# HISTORIC AND DESIGN REVIEW COMMISSION

September 06, 2017

**HDRC CASE NO:** 2017-439  
**ADDRESS:** 1530 E HOUSTON ST  
**LEGAL DESCRIPTION:** NCB 576 BLK 15A LOT 6  
**ZONING:** RM-4 CD  
**CITY COUNCIL DIST.:** 2  
**DISTRICT:** Dignowity Hill Historic District  
**APPLICANT:** Jose Garcia  
**OWNER:** Jose Garcia  
**TYPE OF WORK:** Porch reconstruction, construction of stairway

**FRONT ELEVATION**  
SCALE: 1/4" = 1'-0"

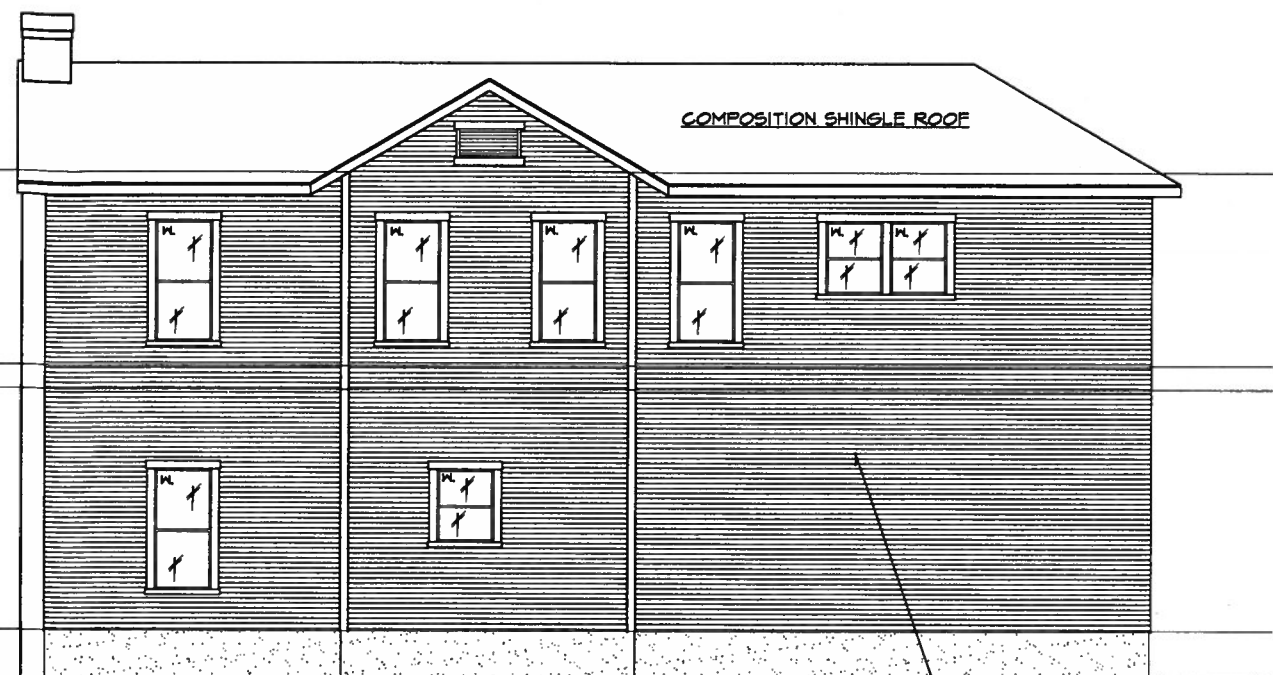
- b. PORCH – The applicant received administrative approval on August 11, 2017 to remove the existing porch due to severe deterioration and life safety concerns. The applicant has proposed to reconstruct the porch to match the original footprint. The porch will feature four columns in the location of the previous columns, with a brick base and tapered wood shaft that meets a simple square capital. The former columns were simple square posts on brick bases. According to the Historic Design Guidelines, replacement porch elements should be compatible in scale, massing, and detail while materials should match in color, texture, dimensions, and finish. Staff finds that the proposed columns are not architecturally appropriate for the style of the home and should be simplified to be more reflective of the original columns.

Item 1, Staff recommends approval of the porch reconstruction and design based on findings a and b with the stipulation that the applicant simplify the proposed columns as noted in finding b. The columns should be straight versus tapered and not exceed 8 inches in width. The applicant must provide final drawings of the columns to staff for review and approval prior to receiving a Certificate of Appropriateness.

**LEFT SIDE ELEVATION**  
SCALE: 1/4" = 1'-0"

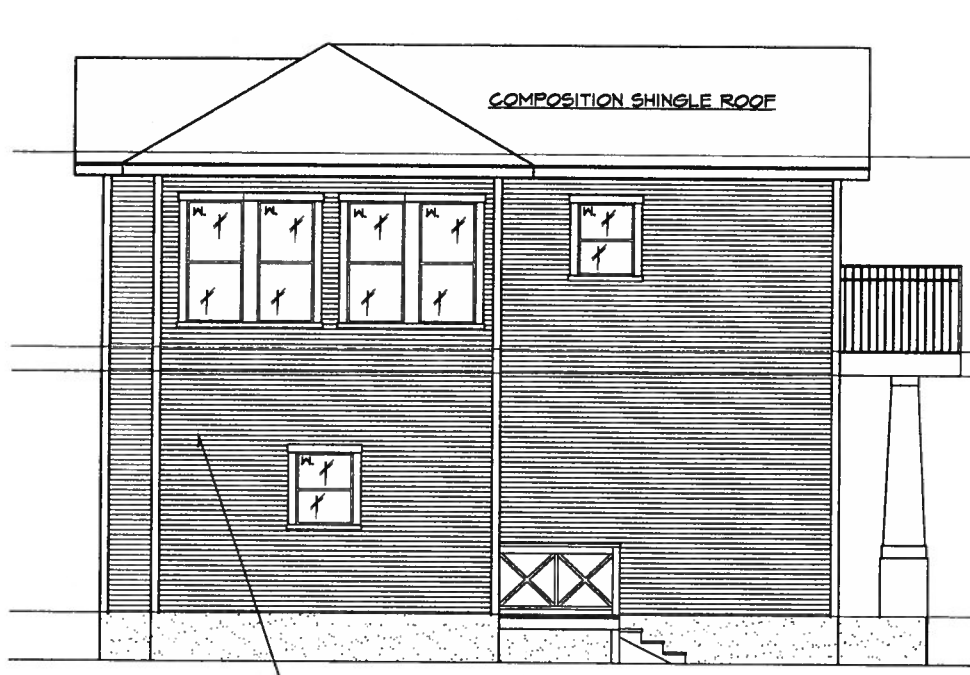
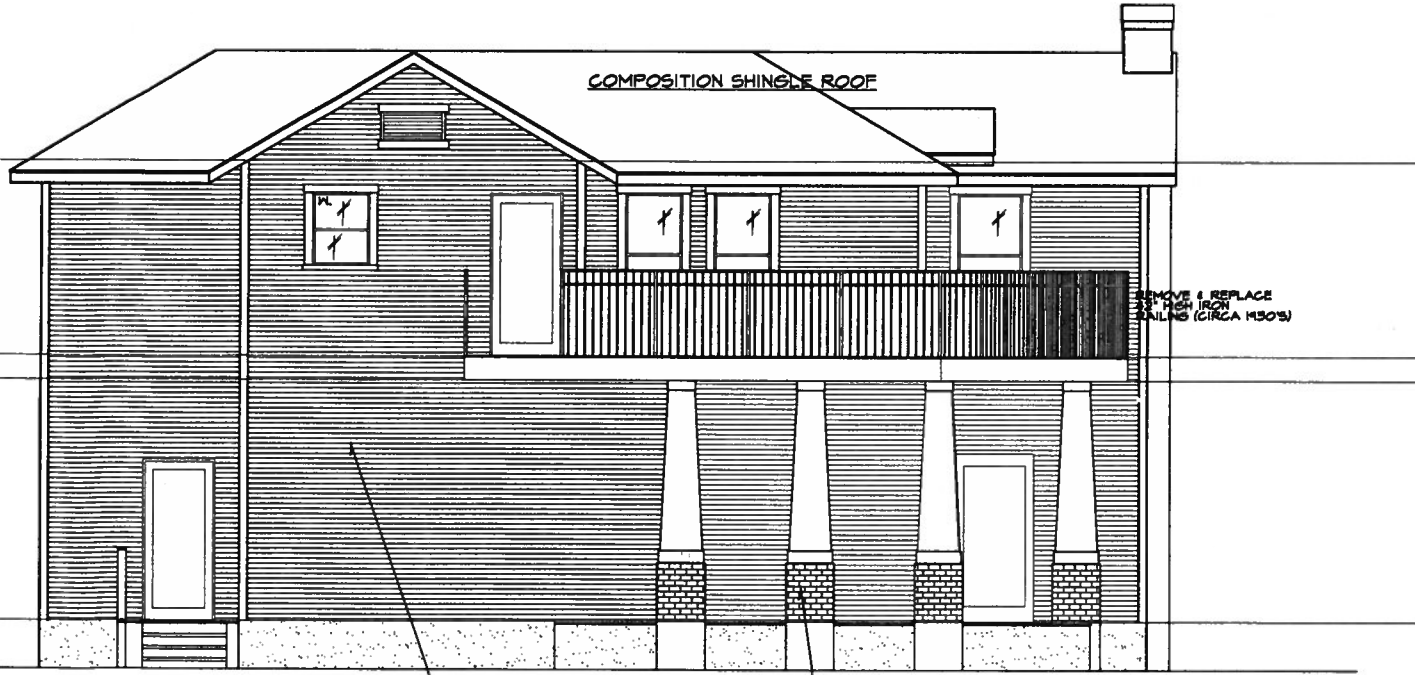
- c. STAIRWAY – The applicant has proposed to construct a new exterior stairway on the west façade to provide access to a second story door. The proposed staircase will replace an existing staircase in the same location. Staff finds the proposal generally consistent with the Guidelines, but has not seen elevation drawings that indicate the design of the staircase or its components, including railing height and design.

Item 2, Staff recommends approval the stairway construction based on findings a and c with the stipulation that the applicant submits detailed elevation drawings to staff for review and approval prior to receiving a Certificate of Appropriateness.
